Subject: Floodplain and Property on Alvarado and Eastern (near San Mateo and Gibson

Grading and Drainage Plan for Mr. B's Paint & Body Shop (L18-D64) Dated RE: December 11, 2001

PRIVATE DRAINAGE FACILITIES WITHIN PUBLIC RIGHT-OF-WAY DRAINAGE FILE NUMBER (L18-D63). PALOMAS SATELITE PARKING, LOVELACE MEDICAL CENTER.

Re: T.C.L. submittal for building permit approval for Lovelace Health Systems-

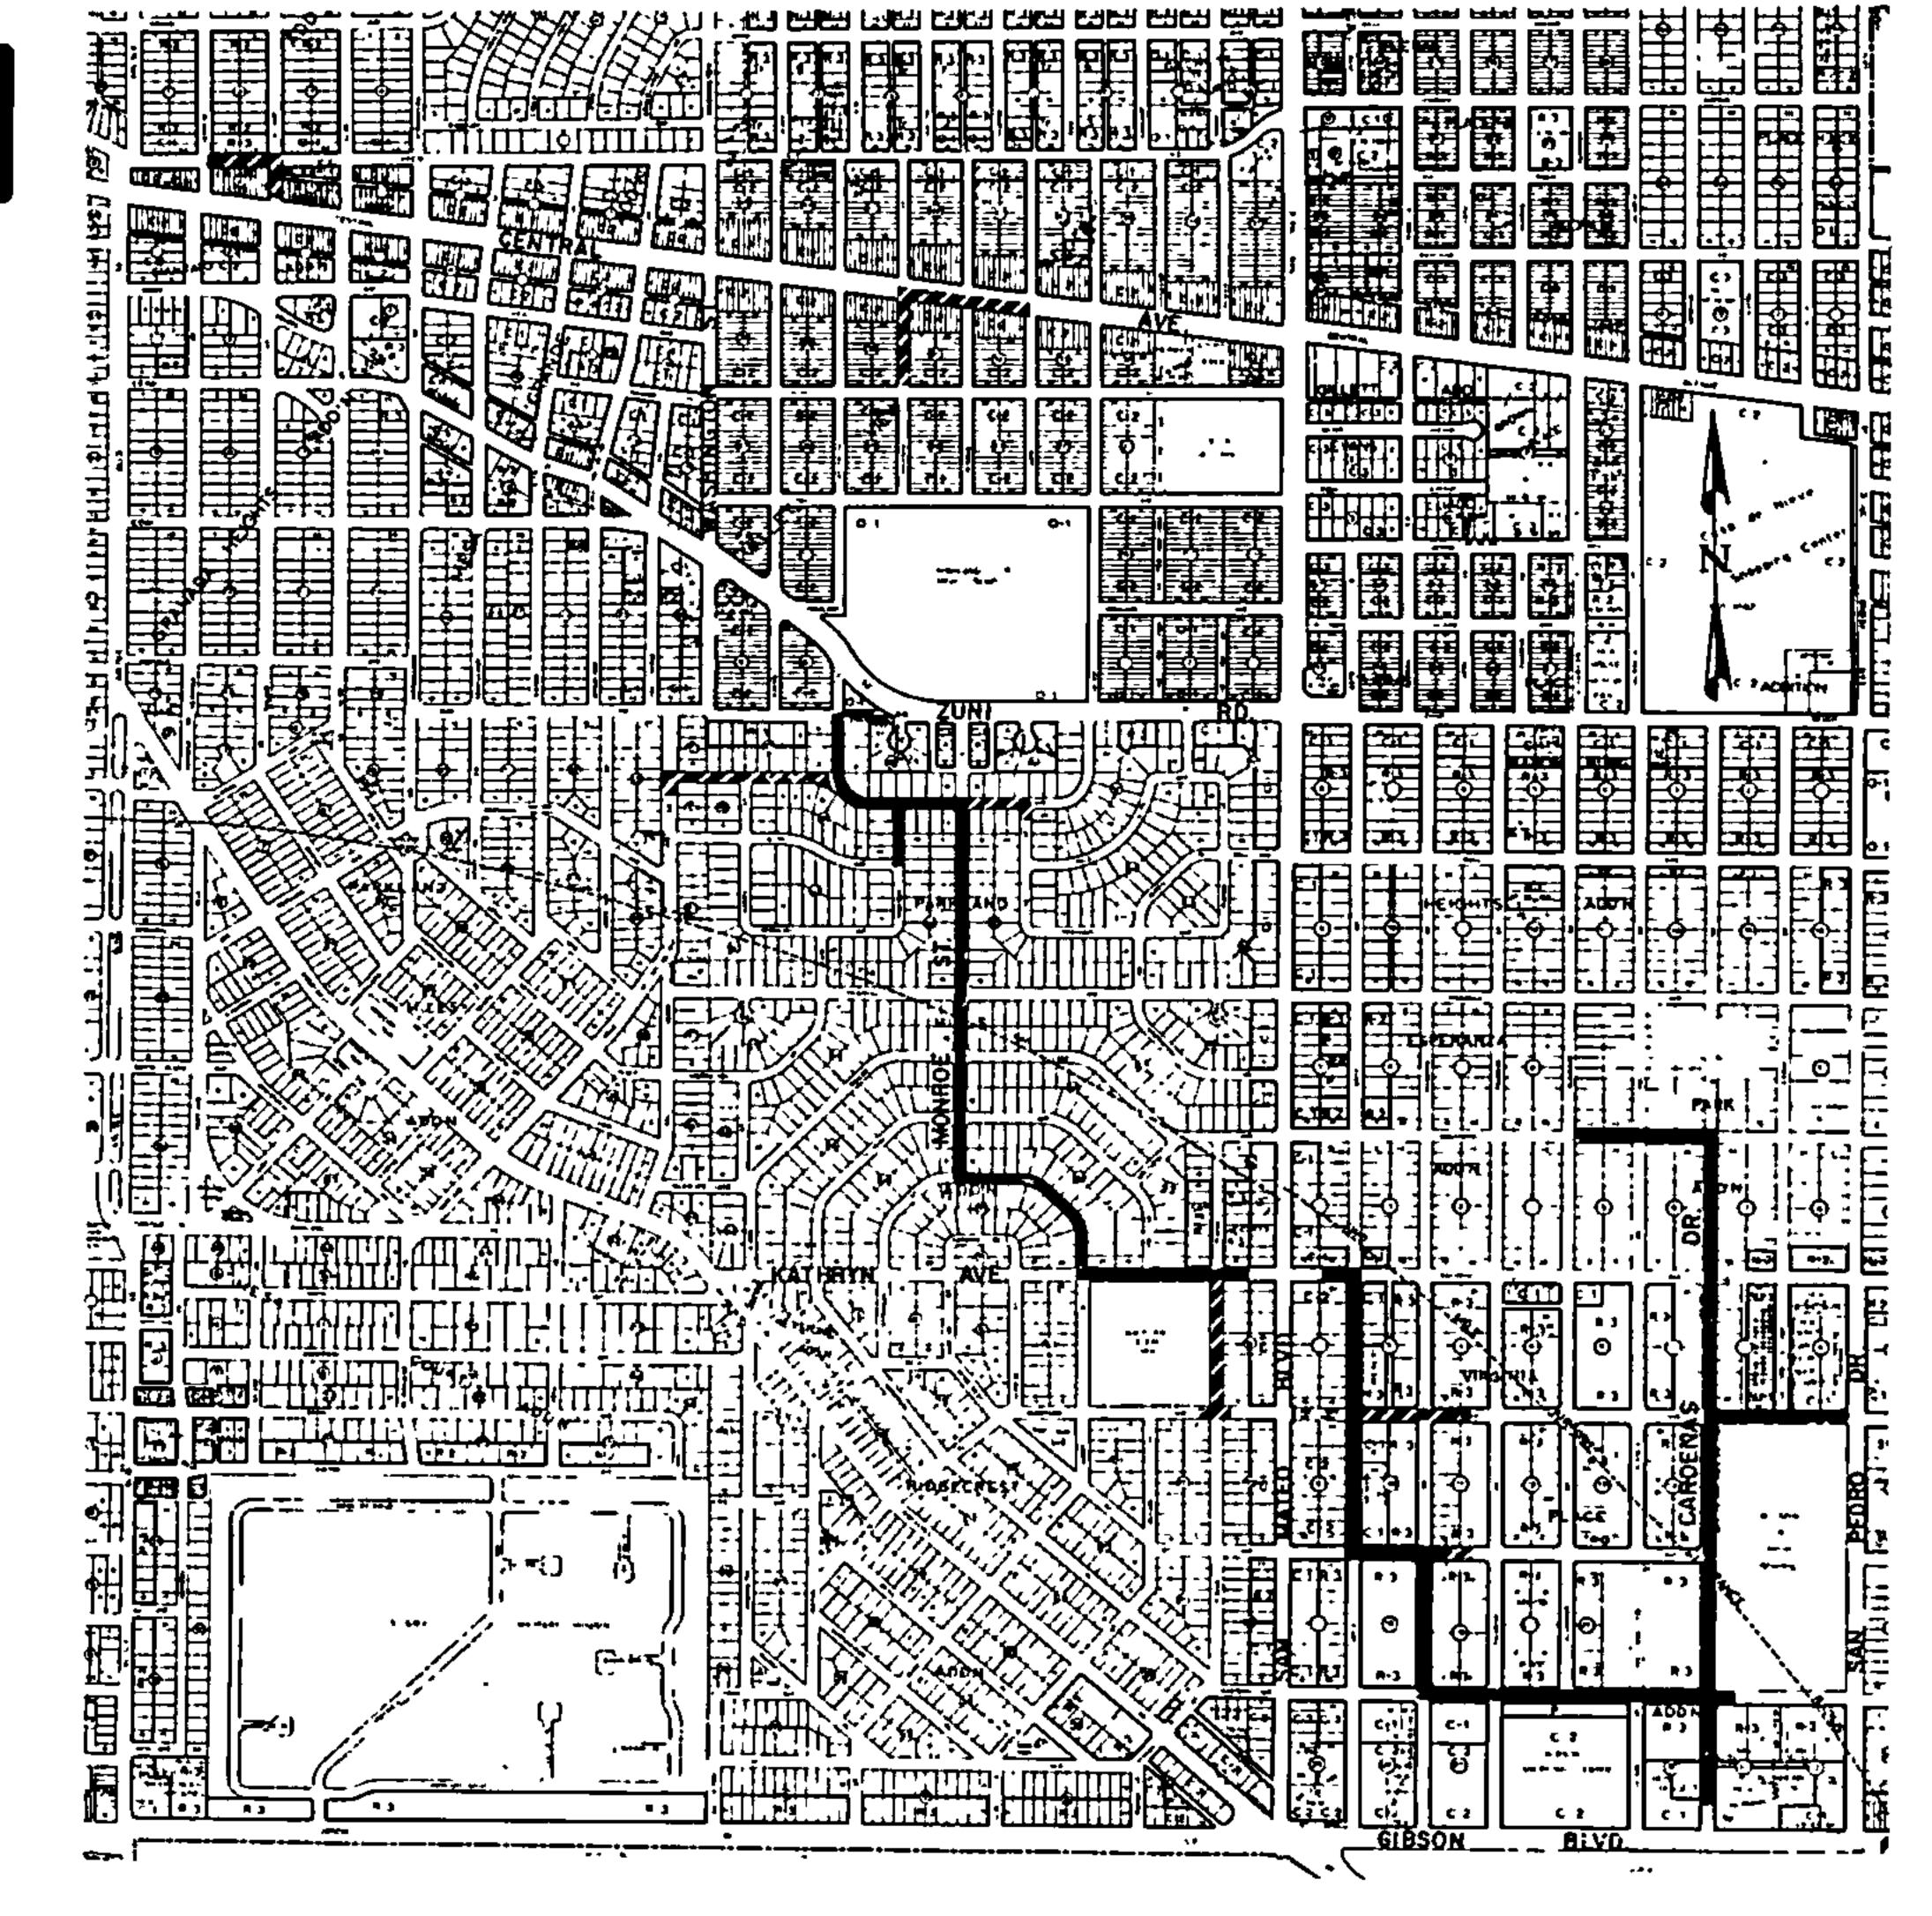
- It lies in SFHA AO (floodzone AO) with a water depth of 1 ft.
- Per COA ordinance the lowest floor elevation of each building needs to be 2 ft above the Highest Adjacent Grade for that building (or 1 ft above the water depth). This means that at least 2' of fill will be required for each building pad.

- There are 2 options for building in a floodzone:
 - 1. Submit a LOMR (Letter of Map Revision) to FEMA showing that with the past improvements (ie. Stormdrain in Gibson) have changed the limits of the floodplain. This would require a study of the larger area up to Kirkland, and submitting a CLOMR to FEMA before the LOMR. A CLOMR (Conditional letter of map revision) is in affect a pre-application to FEMA to determine major obstacles to the LOMR.

- 2. Submit a LOMR-F (Letter of Map Revision based on Fill) to FEMA showing that the building has been elevated by fill and removed from the floodplain. This would require submitting a CLOMR-F to FEMA before the LOMR-F to determine major obstacles. CLOMR-F's are not always required, but in this case because of the amount of fill and the flood-zone necking down at the NW corner, it would be too risky to proceed without a CLOMR-F

- FEMA may require that there be *Compensatory Volume* or *Equivalent Flow Area* be provided. Compensatory volume is the volume of water displaced by the buildings. For example, a park or depressed area could be located between buildings to collect the volume of stormwater displaced. Equivalent flow area is the cross-sectional area of water that flows thru the site. This area may need to be maintained, depending on what FEMA requires. Note the neckdown of the flood-zone at the NW corner. Filling in this site may cause that neckdown to widen and change the flood-zone, thus possibly requiring a LOMR from FEMA. This is another reason a CLOMR or CLOMR-F would be required.
